Office Action Summary	Application No. 10/736,656	Applicant(s) JONES, BRENT R. 	
	Examiner Leonard S. Liang	Art Unit 2853

DETAILED ACTION

FIG. 3

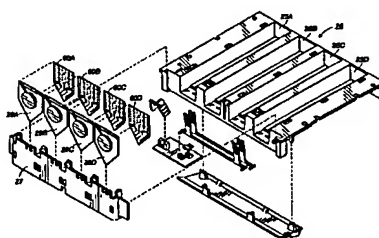
- {claim 1} A solid ink melt assembly for use in a phase change printer (figure 3); a drip plate with first and second sides (figure 3, reference 60A-D); a lower portion of the plate is shaped to form a drip point (figure 4, reference 52); a heater mounted to the first side of the drip plate (figure 3, reference 29A-D); wherein the second side of the drip plate is exposed to ink sticks for melting (figure 3)

- {claim 13} a retaining clip to prevent large scale separation of heater elements from the drip plate (figure 3, reference 27)
- {claim 14} An ink loader for use in a phase change printer (figure 3); at least one channel having an entry end and an exit end (figure 3, reference 25A-D); a melt assembly (figure 3); a metallic drip plate with first and second sides, wherein the lower portion of the plate is shaped to form a drip point (figure 3, reference 60A-D); a heater mounted to the first side (figure 3, reference 29A-D)
